TDD Link Monitor State Diagram

D0.a Comment #XXX

IEEE P802.3dm Task Force

Jan 14, 2026

Figure 202–28—Link Monitor state diagram

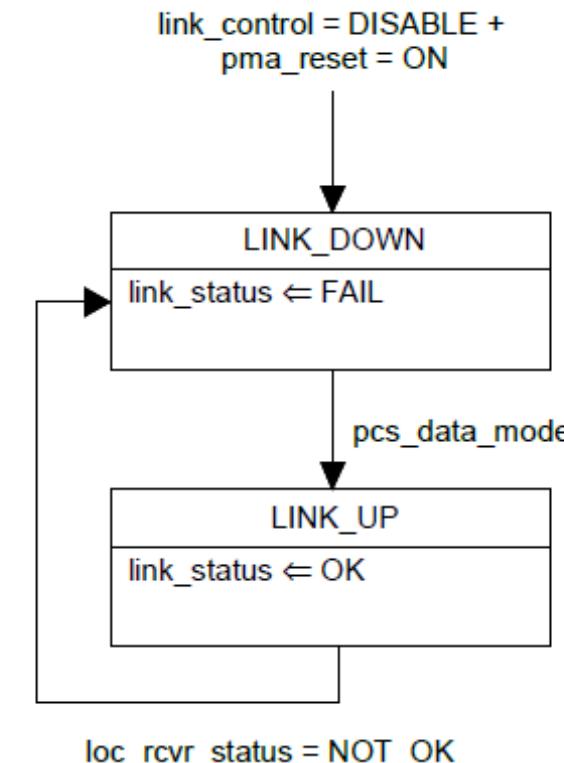
- A new variable “TDD_watchdog_status” is introduced in 202.4.4.1 and Figure 202–28.

- Remove “pma_tdd_status” in 202.4.4.1.
- Remove “tdd_rx_monitor_timer” in 202.4.4.2.
- Remove “The TDD Monitor state diagram is show in Figure 202–29 (TBD).” in 25 line, page 210.
- Remove Figure 202–29.
- Remove subclause 202.4.2.6 TDD monitor function.

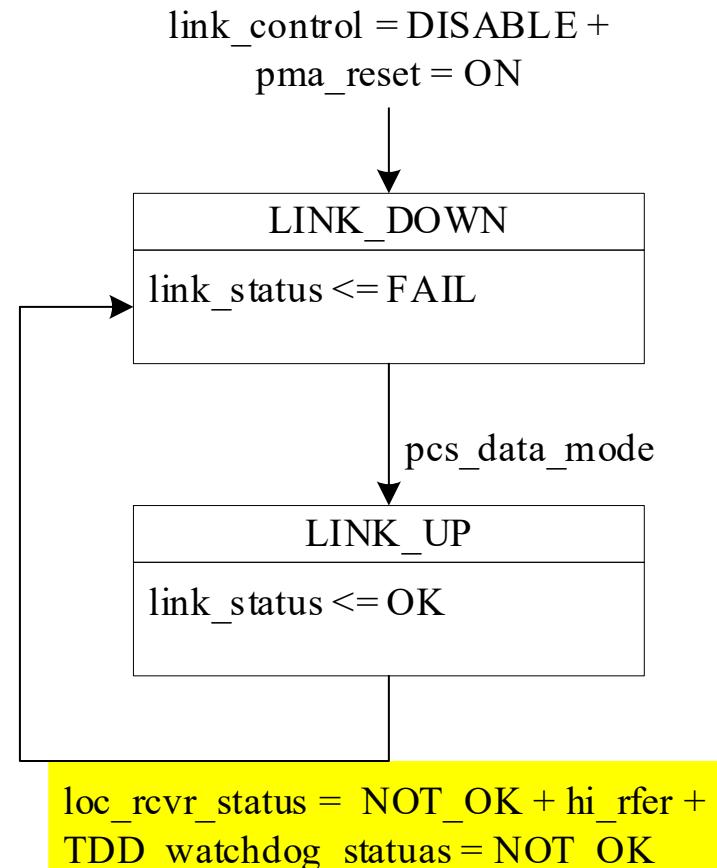
- Update the bottom of Figure 202–28: $\text{loc_rcvr_status} = \text{NOT_OK} + \text{hi_rfer} + \text{TDD_watchdog_statyes} = \text{NOT_OK}$

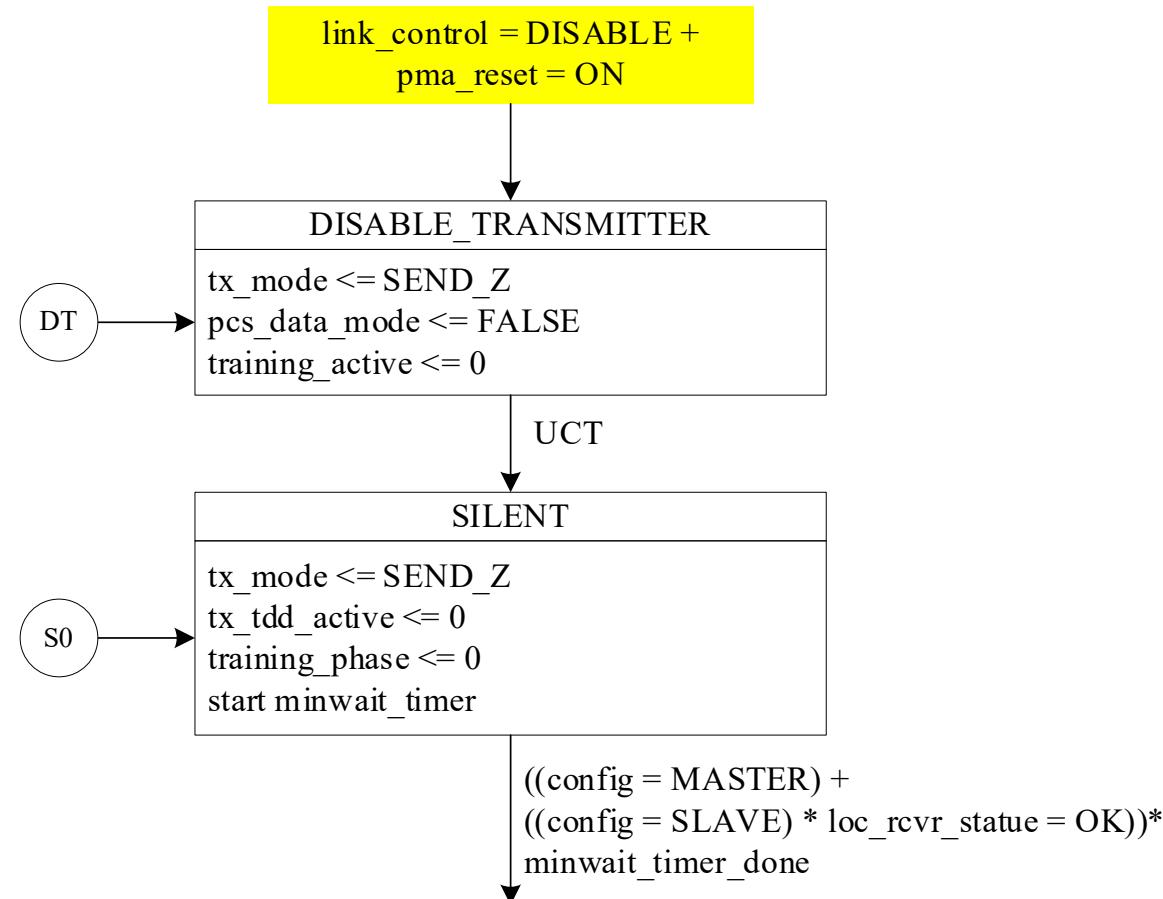
- Update the top of Figure 202–26: $\text{link_control} = \text{DISABLE} + \text{pma_reset} = \text{ON}$
